5.1 NO. 4 (LOT: 1; S/P: 24447) PRIMROSE STREET, PERTH - PROPOSED ALTERATIONS AND ADDITIONS TO GROUPED DWELLING

RECOMMENDATION:

Design Review Panel:

PLANS
PROPOSED GROUND & FIRST FLOOR

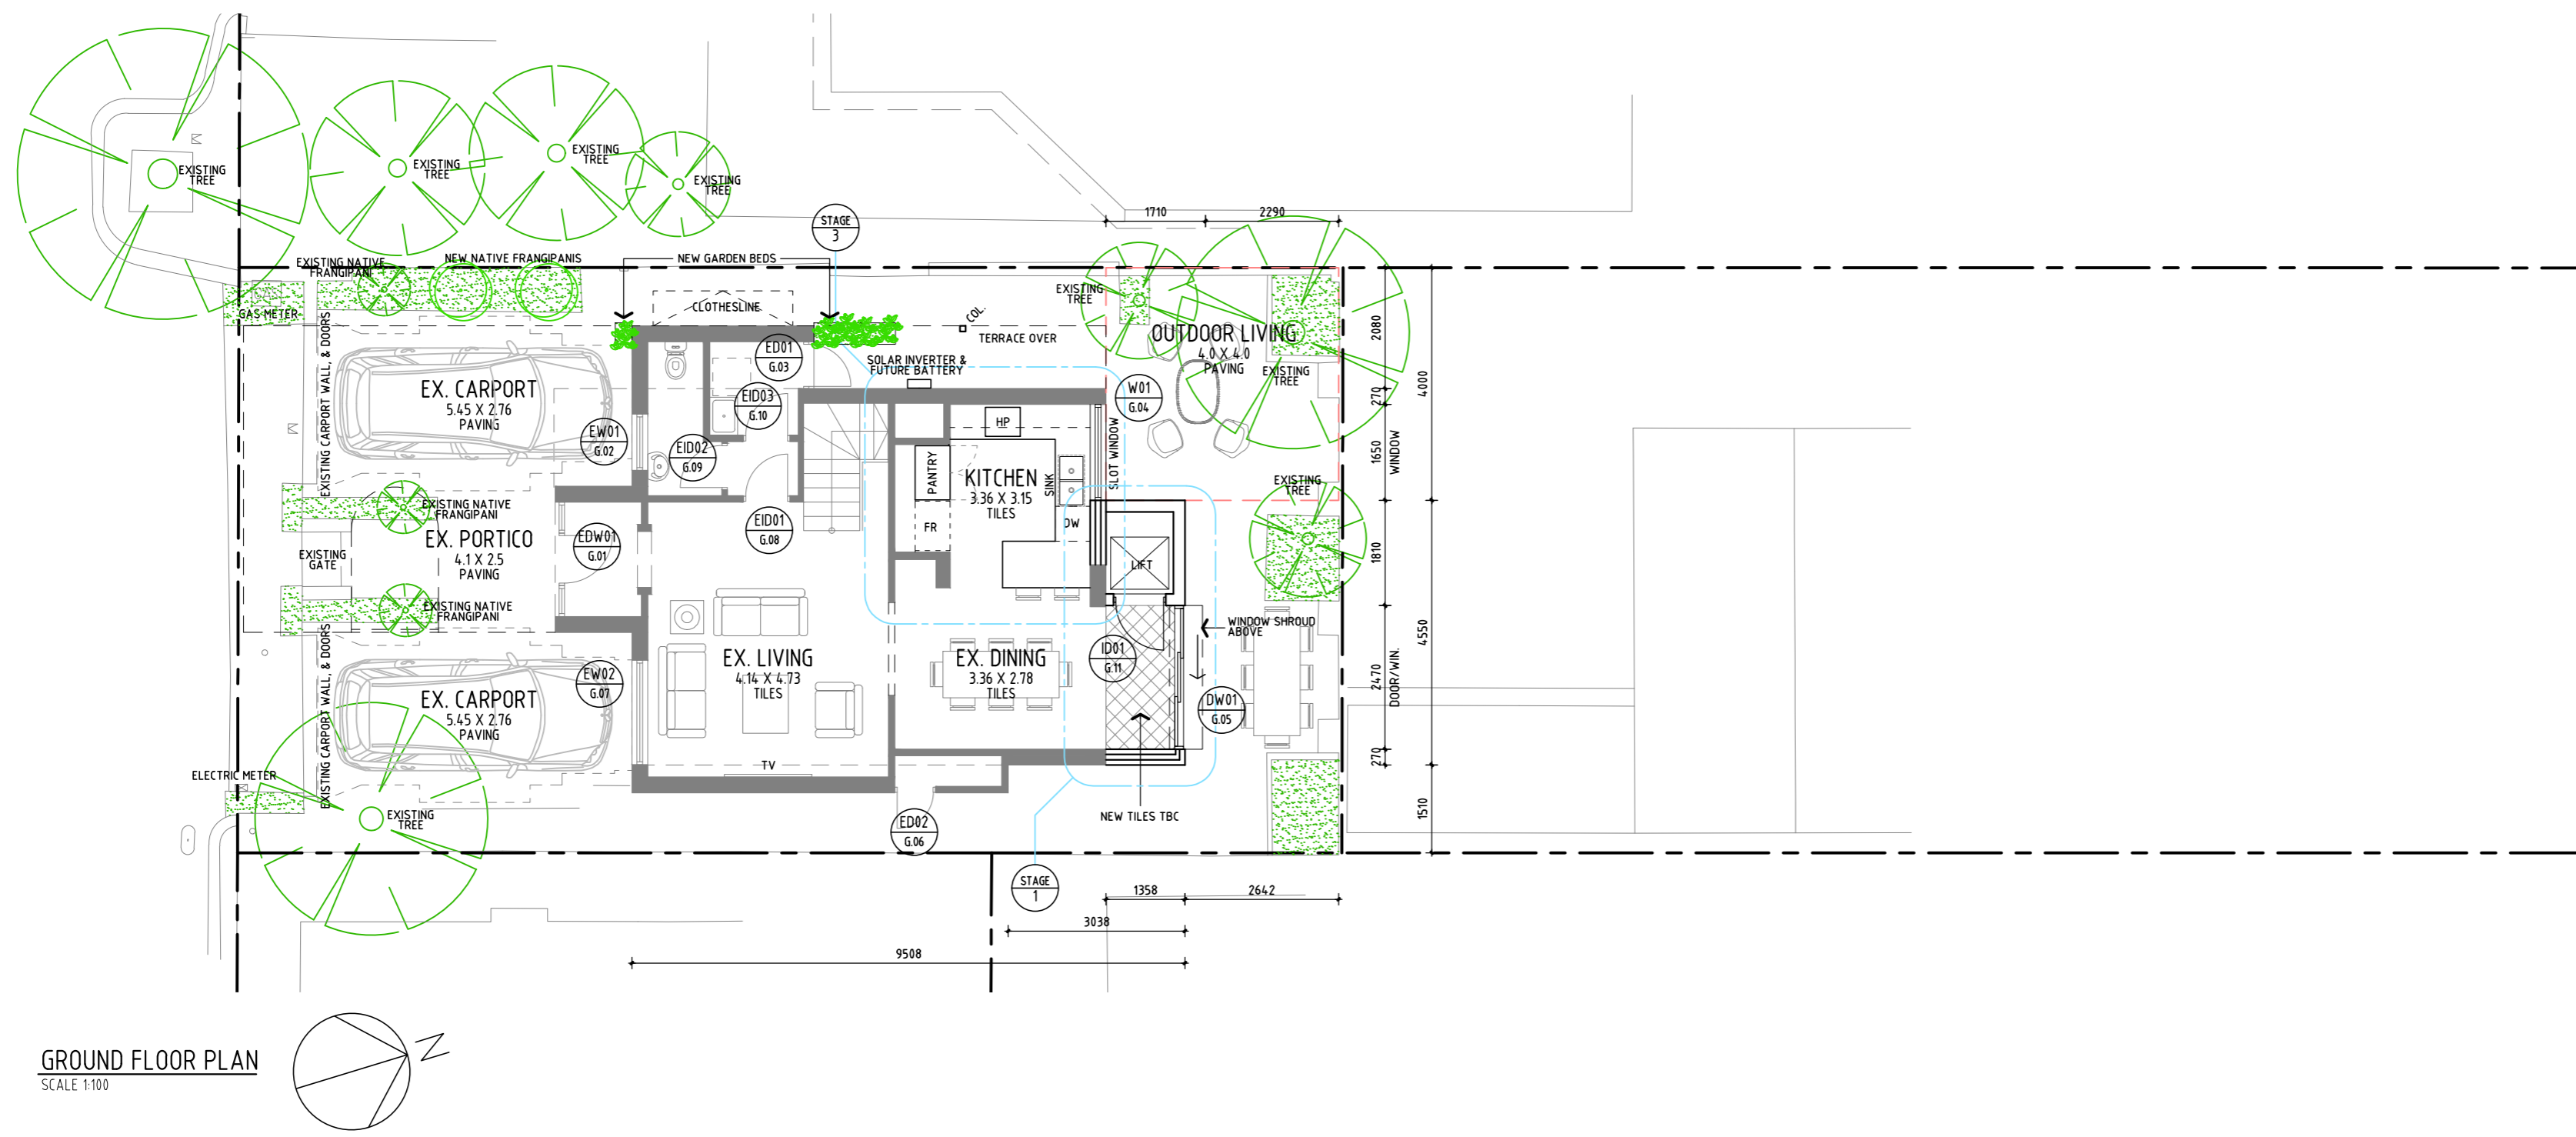
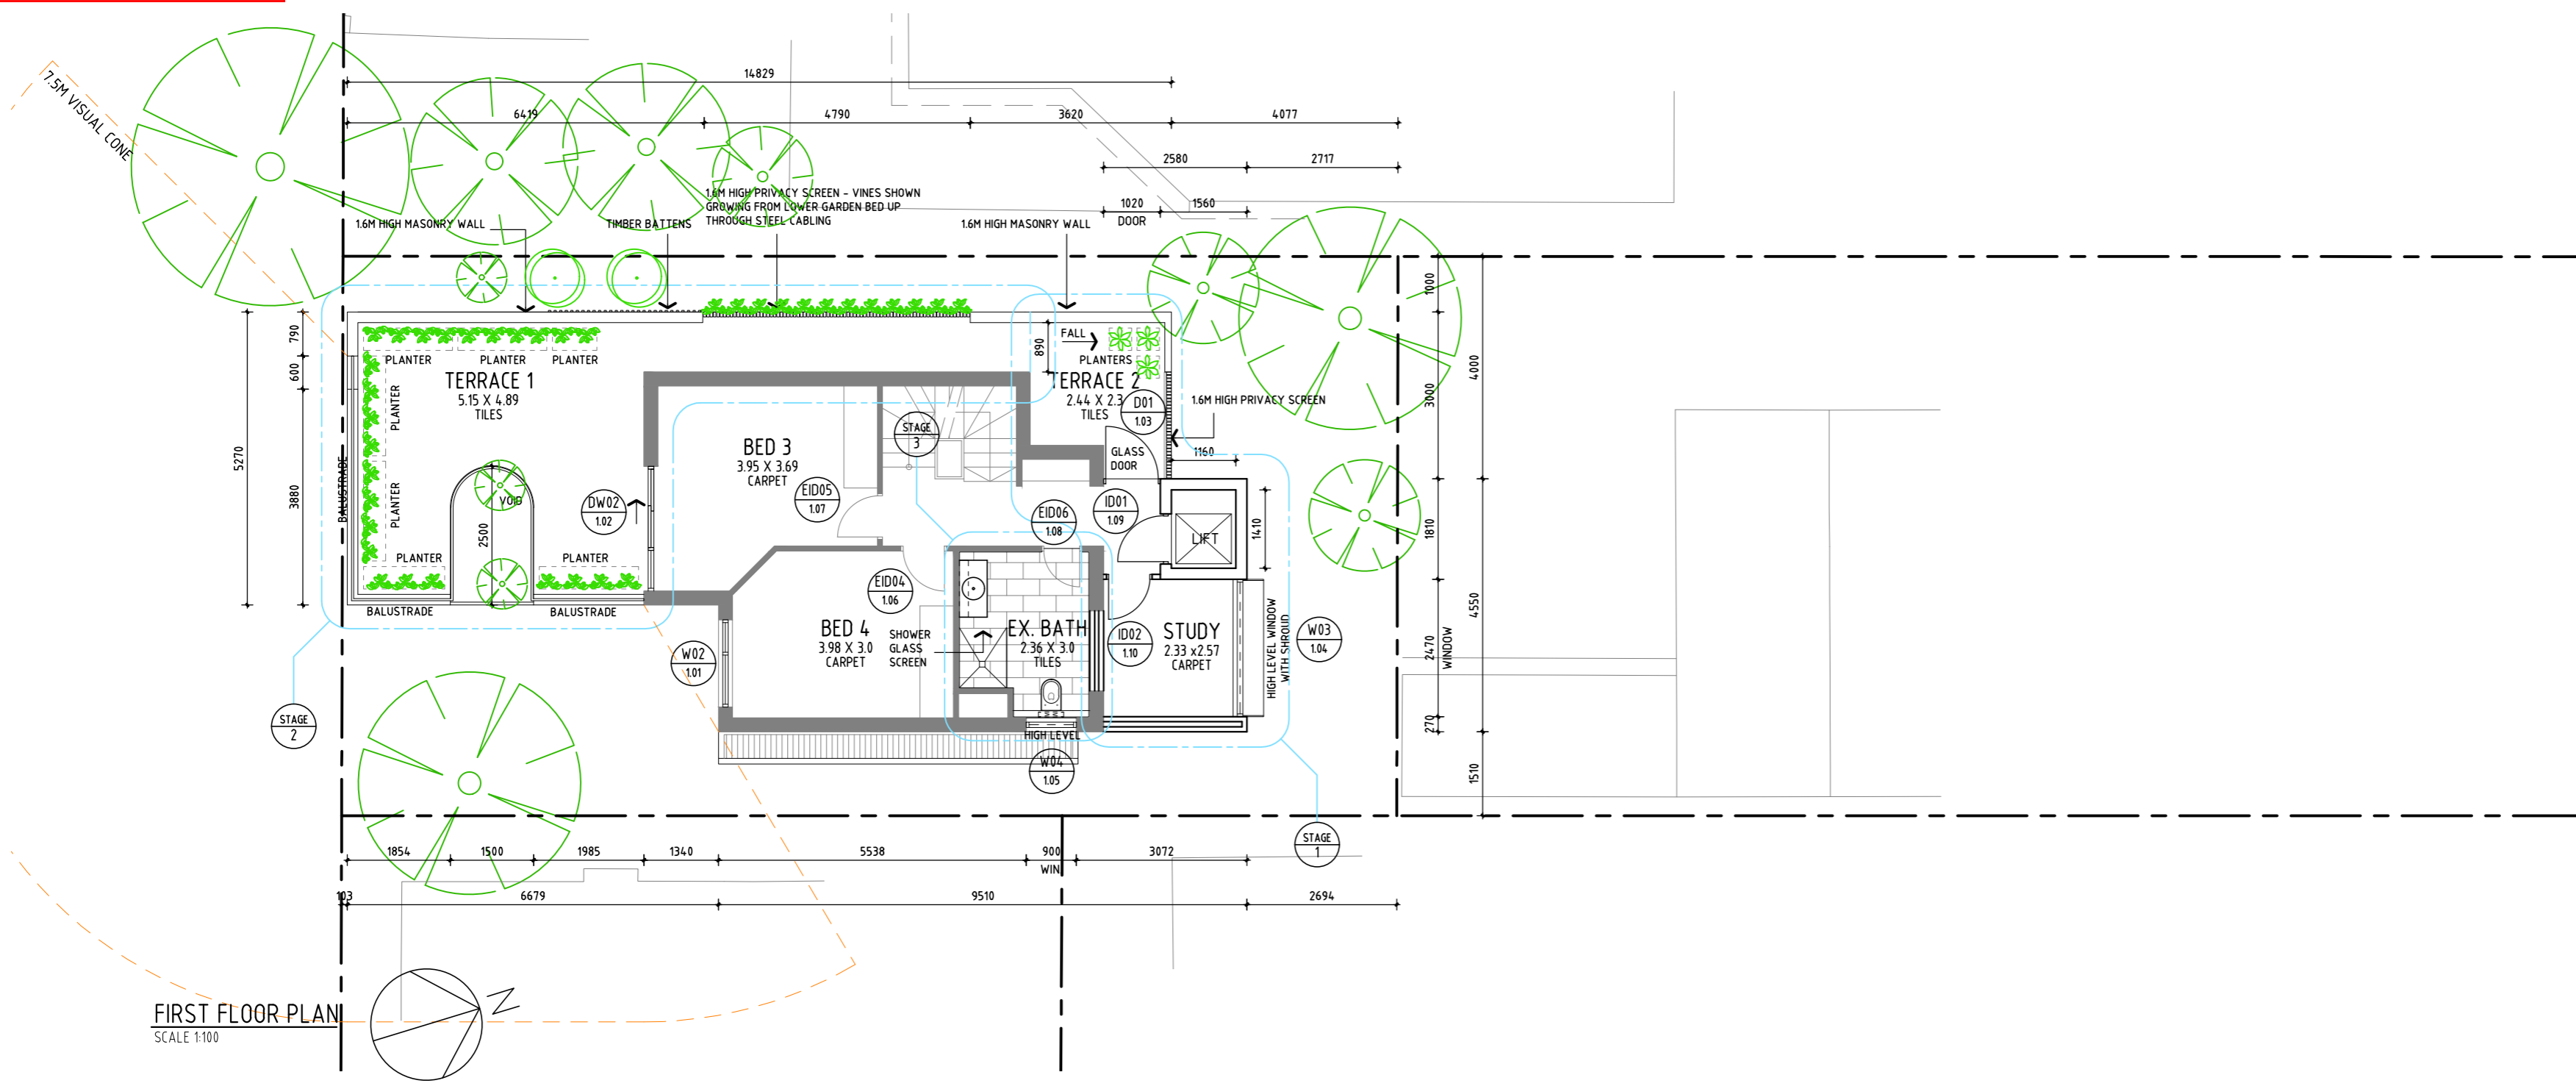
- Built Form and Scale – Visual privacy to the east from the terrace is still non-compliant. The justification notes a Frangipani tree which is a deciduous tree and therefore doesn't assist with this during some times of the year. It is acknowledged the terrace may look onto a three storey solid wall however visual privacy also needs to be considered in relation for the potential for adjoining sites to be redeveloped in the future. The recommendation to achieve green in Built Form and Scale is to make overlooking of the east property from the terrace compliant with screening given this is easy to achieve and the terrace can still achieve an outlook to the south over the laneway.

In accordance with the Built Form Policy and R Codes, the deemed-to-comply lot boundary setback is 1.7 metres from the western lot boundary. The proposed terrace provides a 1.0 metre setback from the western lot boundary.

- Landscaping: Landscaping planters are proposed to the eastern edge of the terrace. This would provide landscaped screening and a condition of approval is recommended for this to be installed. A large, well-established and mature tree is also present on the eastern lot boundary of the subject site that would provide natural screening to the eastern adjoining dwelling.

In response to the 29 March 2023 DRP Chairperson comments, the applicant proposed the addition of on structure planting along the eastern edge of the terrace.

- The inclusion of additional on structure planters provides sufficient screening to the adjoining eastern lot.
- It is noted that the previously provided requests for modifications to the Primrose Street frontage have not been implemented. Due to the ground floor façade (garage and front door) being retained as existing, the applicant has limited opportunity to further improve the legibility of the dwelling. As such, the proposed and existing legibility of the proposed development is supported.

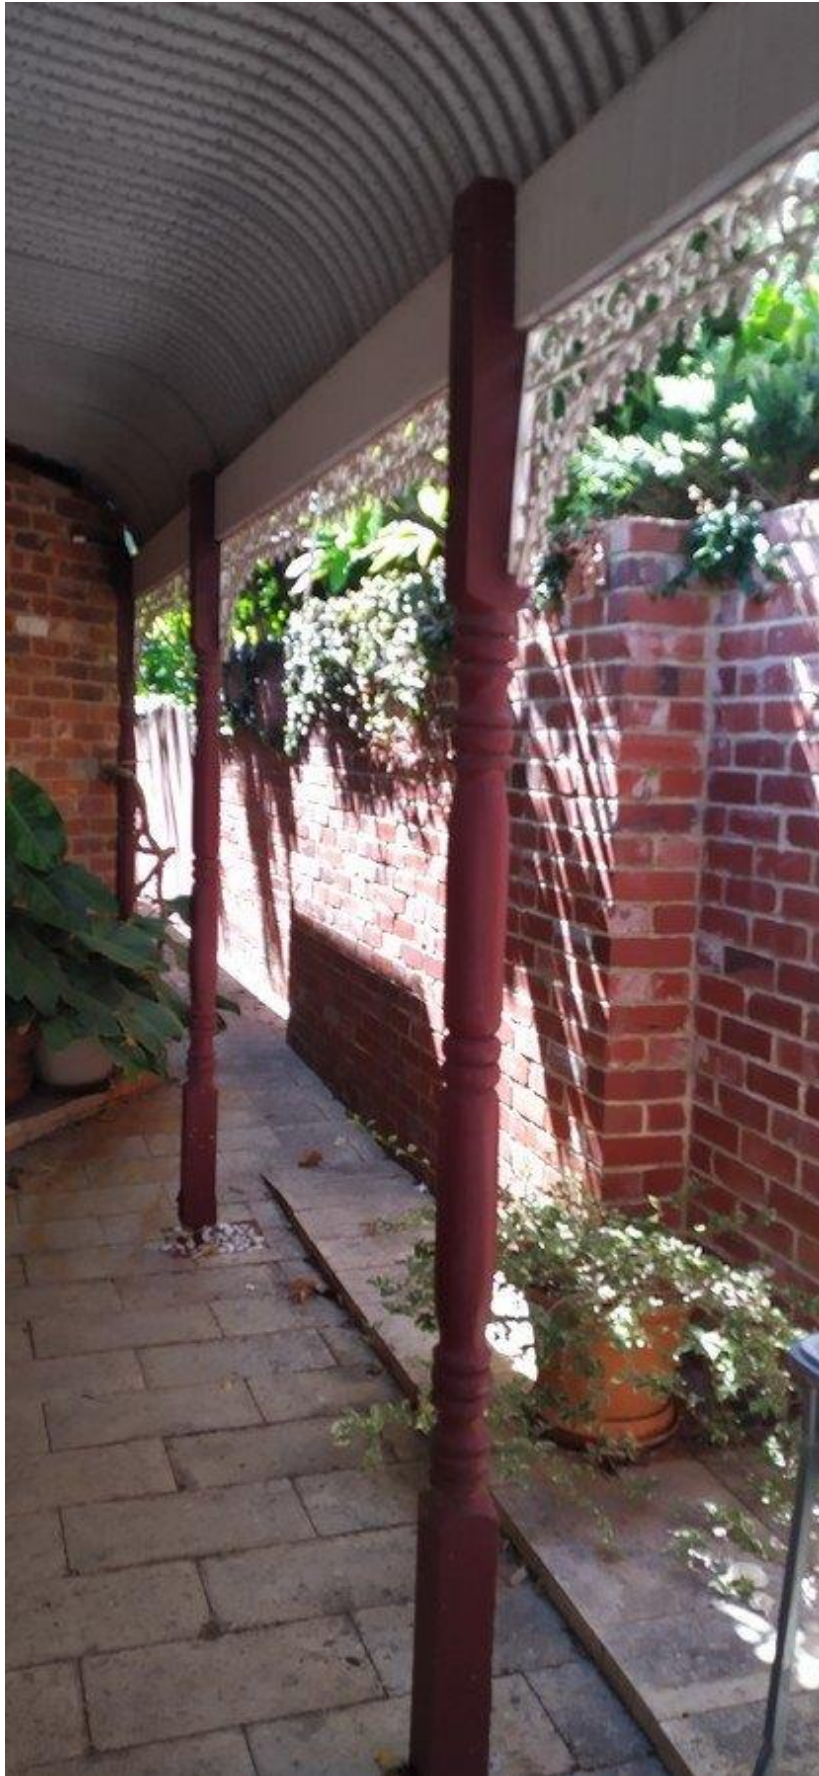
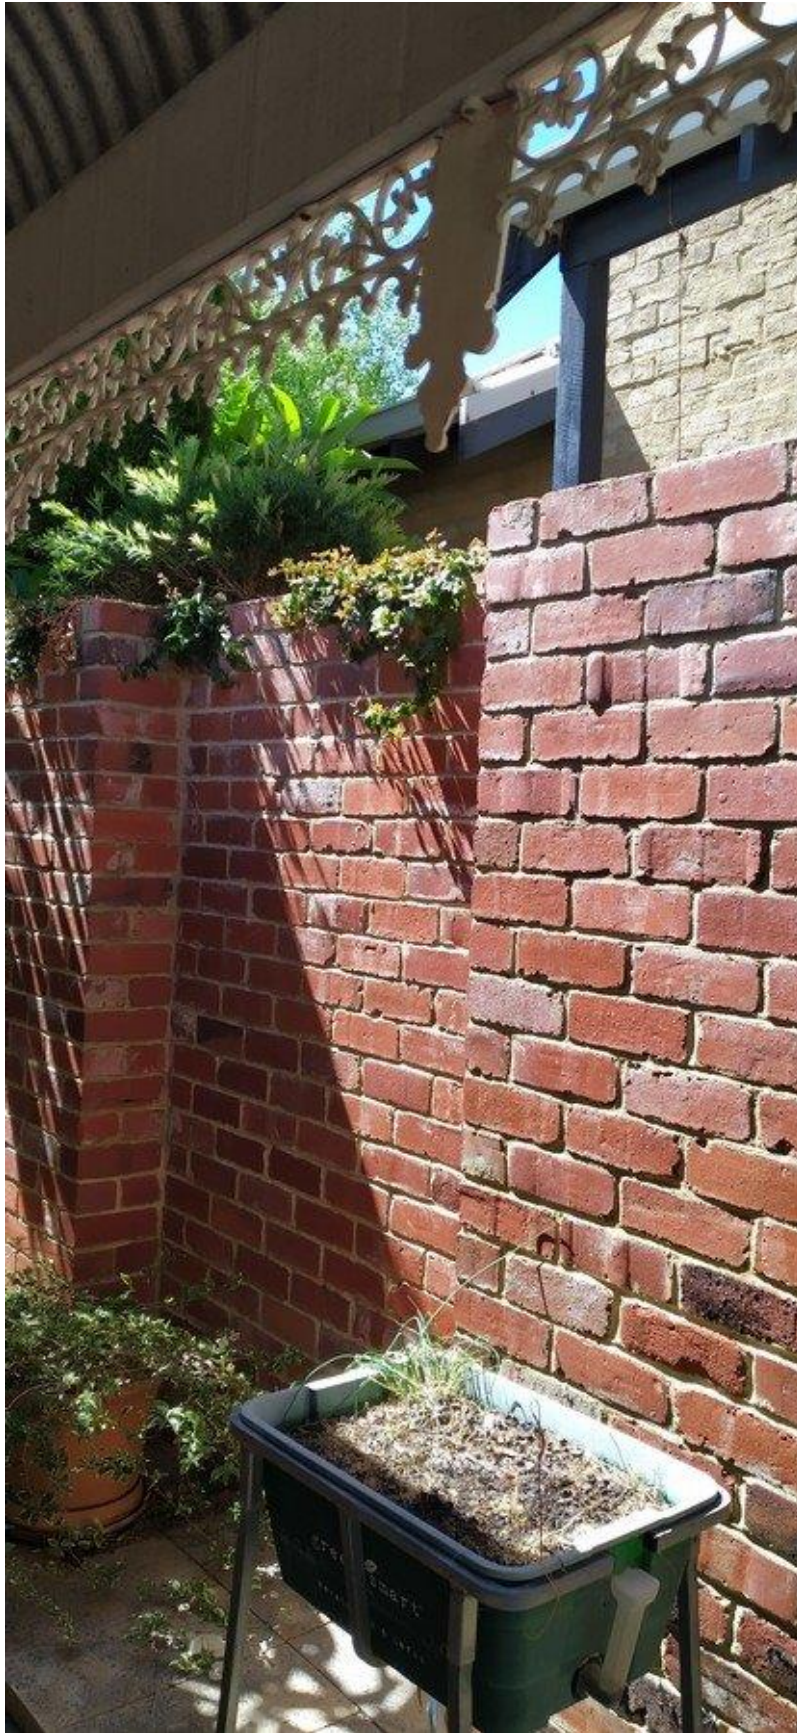
Figure 5: Existing bullnose verandah and boundary fence of 57 Glendower St providing visual cut-off and limiting field of view to adjoining property at 4 Primrose St

Figure 6: Existing bullnose verandah and boundary fence of 57 Glendower St providing visual cut-off and limiting field of view to adjoining property at 4 Primrose St
